Magnet/Syringe Separation Issues
V.B. Graves
8/12/05

This document is an initial response to the results of Peter's analysis on the attractive forces between the magnet and the steel hydraulic cylinders in the baseline syringe pump design.

Fig. 1. Existing Design

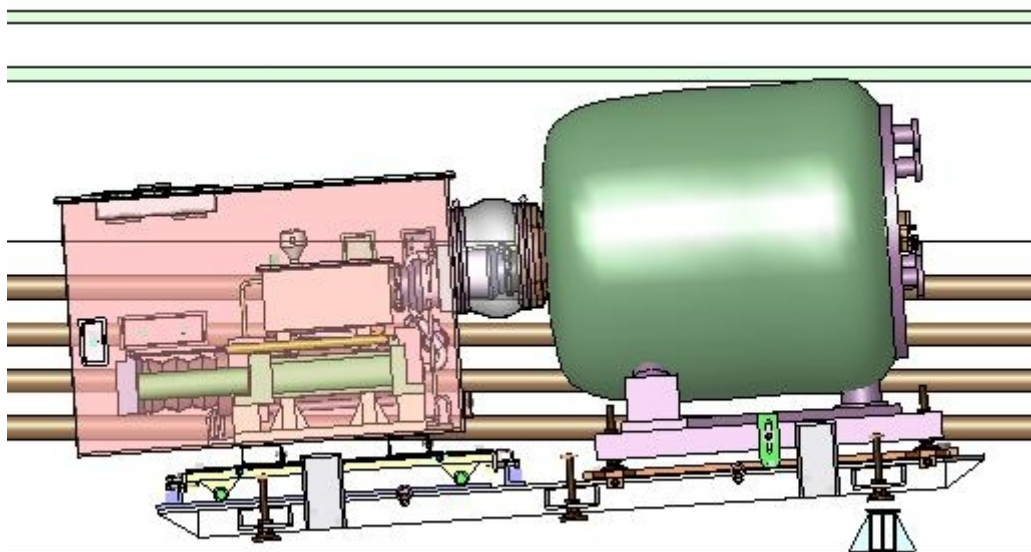
To minimize changes to the current design (Fig. 1) this separation would most easily be accomplished by increasing the length of the flexible hoses between the sump tank and the target module, keeping the sump tank and cylinders inside a secondary container box. The secondary bellows surrounding the Hg supply and return lines would necessarily lengthen as required. Conceptually this is shown in Fig. 2. This change has several implications on the design, some positive in nature and some negative. I have listed some of these below, but I'm sure that more will develop as the redesign progresses. *Those issues that deal with the cylinders must be resolved prior to the syringe pump procurement.*

Fig 2. Separated System (use your imagination to insert the target module into the magnet). Magnet elevated to beam height, syringe system on floor. Intermediate hose supports not shown.

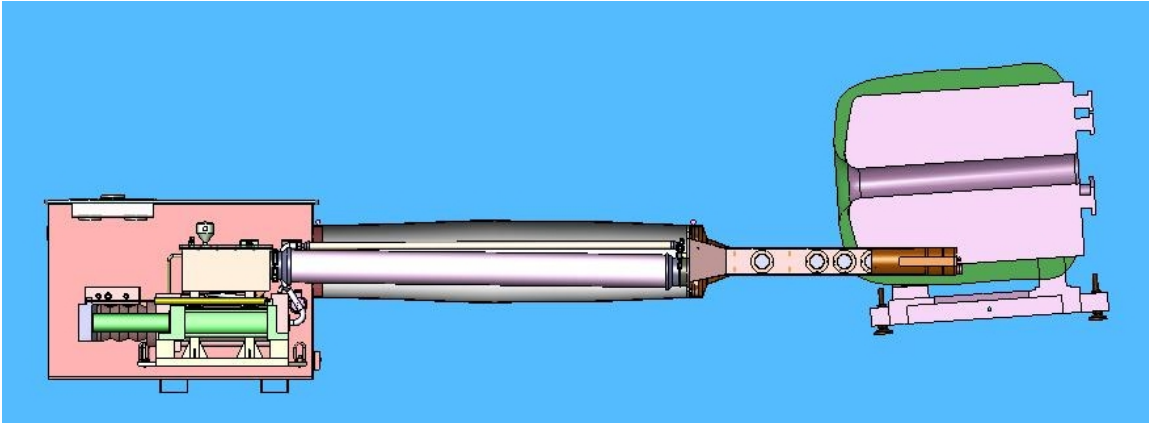
- The common baseplate cannot be extended 2m in length due to the fixed beam elevation and facility constraints both at MIT and CERN. This implies that a common baseplate is not needed. However, it is still required that the magnet be elevated, tilted, and aligned with the beam, so some sort of magnet baseplate will be necessary. Because it already incorporates a means to perform alignment adjustments, one option would be to shorten the current baseplate so that it only supports the magnet.

- With flexible hoses, the syringe does not have to be tilted and may sit directly on the floor (or a mobile baseplate).
- The syringe system no longer has to be directly in line with the magnet or beam, which would allow some flexibility in positioning. This may be beneficial during integrated tests at MIT.

- With 2m of flex hose, the target module might be manually inserted into magnet, so syringe system does not require rolling cart. Estimated weight of the target module is 100-150 lbs.

- With no magnetic attraction forces to deal with, carbon steel cylinders, rods, and pistons can be used in the drive cylinders. The Hg cylinder will still be designed for water service (i.e., chrome plating cylinder walls, piston, rod)
- Because the syringe is no longer interfaced to the magnet through the common baseplate, minimizing the syringe length is no longer a driving requirement. The Hg cylinder diameter could decrease from 10" to 8", putting it in the "low-cost" family of cylinders. With an 8" Hg cylinder, maintaining the 12-sec jet requirement will increase the required stroke by 8" and the total extended length by approximately 13".

- Added flex hose will require support to prevent sag due to Hg weight.
- Flexible hoses have internal convolutions that will trap Hg in these slightly-sloped hoses and will have more flow resistance than rigid pipe. For flow reasons, it would be preferable to use rigid pipe for most of the new length with flex hoses on one or both ends. Use of 2m of rigid pipe makes it impractical to ship and transport assembled system (syringe, pipe, target module), so assembly and disassembly of the primary containment would be required at MIT and CERN. However, the use of rigid pipe is not absolutely required, and the desire to not open the primary containment in the MIT and CERN facilities probably overrides the flow issues.

- Pressure drop across 2m of new pipe will be calculated; increasing pipe diameter reduces pressure drop but would require additional Hg inventory.
- Additional length of pipe requires additional Hg inventory to pre-fill supply line prior to syringe actuation (2m of 1" pipe will require approx 1 additional liter). Some slightly increased amount of cylinder stroke will be lost to pre-filling the additional volume.

- The 6" diameter Hg return hose is fairly expensive (\$2100 for 18.25 inches), so adding another 1.5m is not an insignificant expense. I will probably go with a smaller diameter hose for the return line.

- Since they interface through the secondary containment box, hydraulic lines, sensor wires, ?scintillator?, and optic fiber bundles will have to be longer since they will be further from the TT2/TT2A junction. The fiber bundles and scintillator cables will be inside the flexible secondary containment along with the Hg supply and return lines.

Fig. 3. Existing target module bracing method

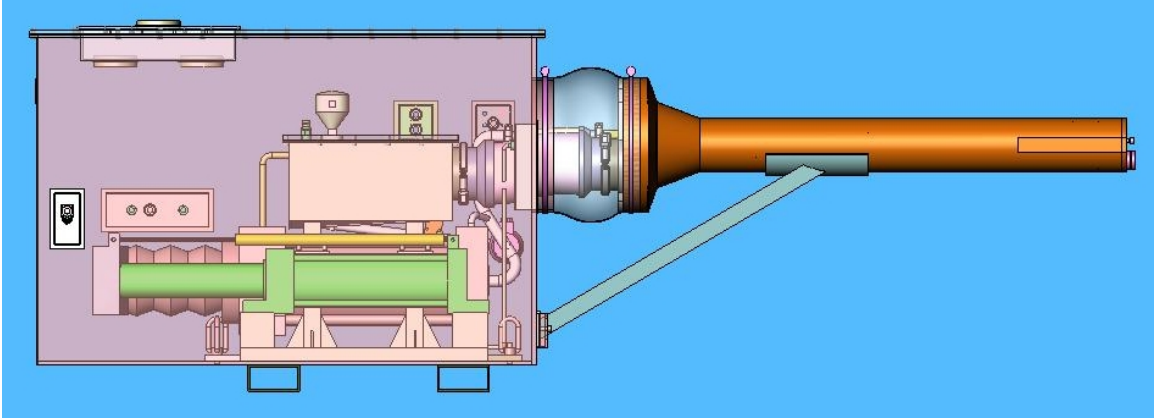
- Because the syringe pump & containment box would be positioned below the beam, the downstream secondary beam window would move to the target module rather than the secondary containment box.
- Downstream end of target module would require changes to accommodate different secondary containment.
- Supporting the target module off of the secondary containment box from 2m away is not practical (see Fig. 3). Secondary containment baseplate could have provisions for storage of target module.
